PRODUCT/SERVICE BULLETIN

RE: 2007 Essex and Mountain Aire built JAN 06 thru JUL 06

RELAY ROTATION WITH INSTALLATION OF ADAPTOR PLATE KIT - RAP91917.

TOP VIEW OF POWER UNIT WITH RELAY A IN THE VERTICAL POSITION

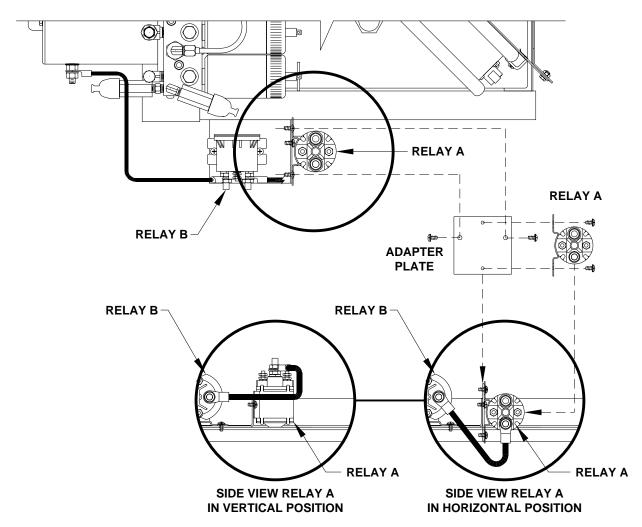
On units built within the above time frame, relay A is mounted in a vertical position. In order to avoid moisture accumulation at the base of relay A use the adapter plate provided to rotate the relay 90 deg.

If relay A is mounted in the horizontal position, no modification is necessary.

(KIT INCLUDES A NEW RAP7505 RELAY)

IMPORTANT: Over tightening the terminal nuts will cause damage to the relay. The manufactures torque specifications are 60 inch lbs. max. for the contact terminals (large posts) and 12-18 inch lbs. for the coil terminals (small posts). (A back-up wrench must be used to hold the bottom nut stationary.) All terminals of both relays should be coated to prevent corrosion. The use of Red Air Dry Enamel, number B6-665 by P.D. George Company is recommended.
